# **NATIONAL FIRE PROTECTION ASSOCIATION**

## **NEC® Code-Making Panel 2 Second Draft Meeting Agenda**

**October 18 - 22, 2021**

## **Attachment C: Public Comment Report**

Figure 2

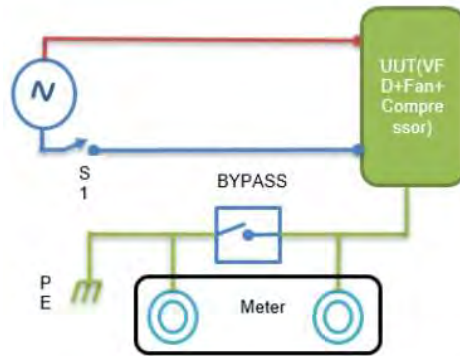
It is important to note that there is a difference between “leakage current” and “touch current.” IEC60990:2016 defines “TOUCH CURRENT” as “electric current through a human body or through an animal body when it touches one or more accessible parts of an installation or of EQUIPMENT.” Figure 5 from IEC60990:2016, reproduced below, shows a test setup and measurement network for touch current. (see attached figure#1)

Simplified Test Set-up (see attached figure#2)

Figure 4: 14/2 CCA Spaced 12" in R43 Insulation at 10 Amps in Ceiling Configuration

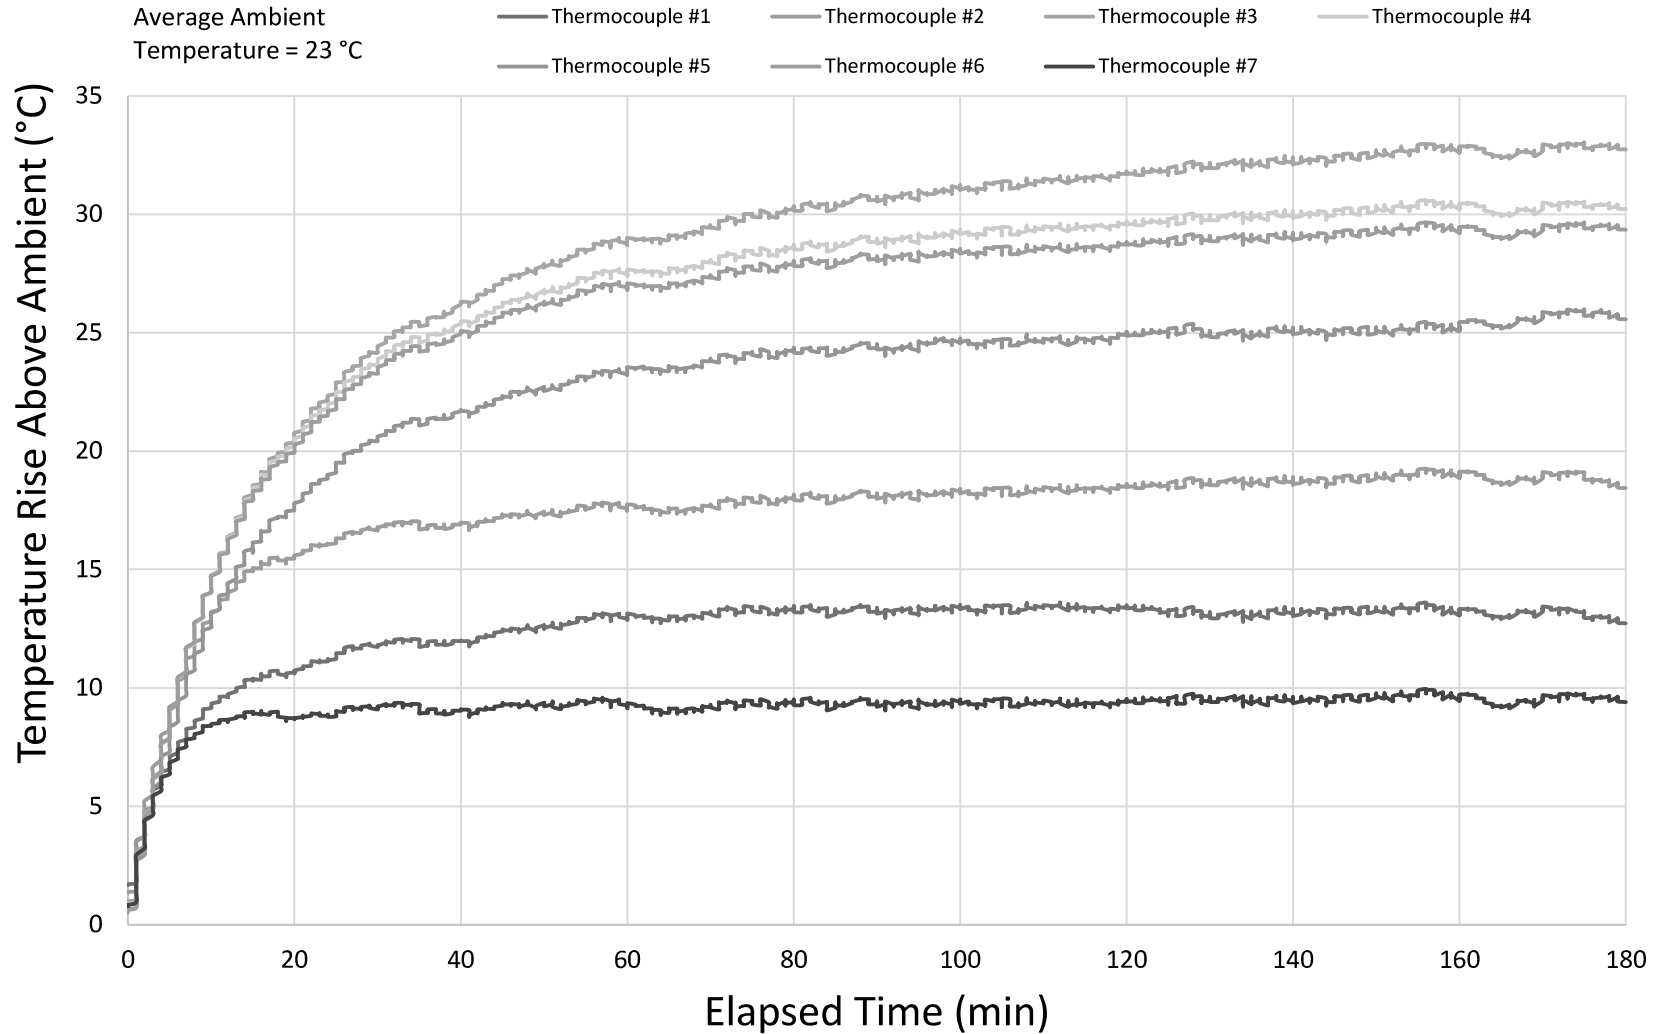
See Figures 4 and 5 below for the temperature profile for AWG 14/2 copper-clad aluminum and 14 AWG THHN copper-clad aluminum while the apparatus was in the ceiling orientation. See Figures 6 and 7 for data in the wall orientation.

**Figure 210.52(C)(2) Determination of Area Behind a Range, Counter-Mounted Cooking Unit, or Sink.**

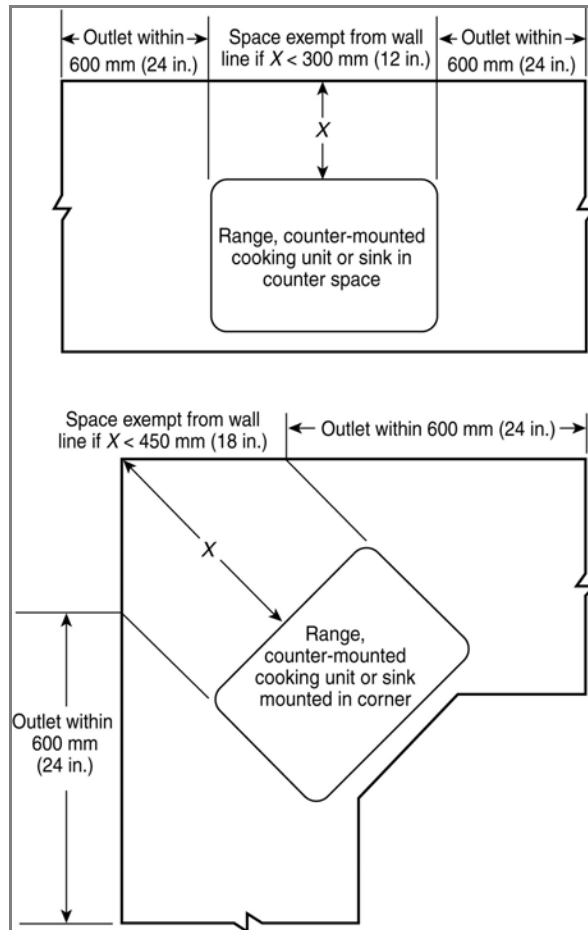
*Exception No. 2 Where a required receptacle outlet cannot be installed in the wall areas shown in Figure 210.52(C)(2), the receptacle outlet shall be permitted to be installed as close as practicable to the countertop area to be served. The total number of receptacle outlets serving the countertop shall not be less than those required in 210.52(C)(2). These outlets shall be installed in accordance with 210.52(C)(4)(1) or 210.52(C)(4)(2).*
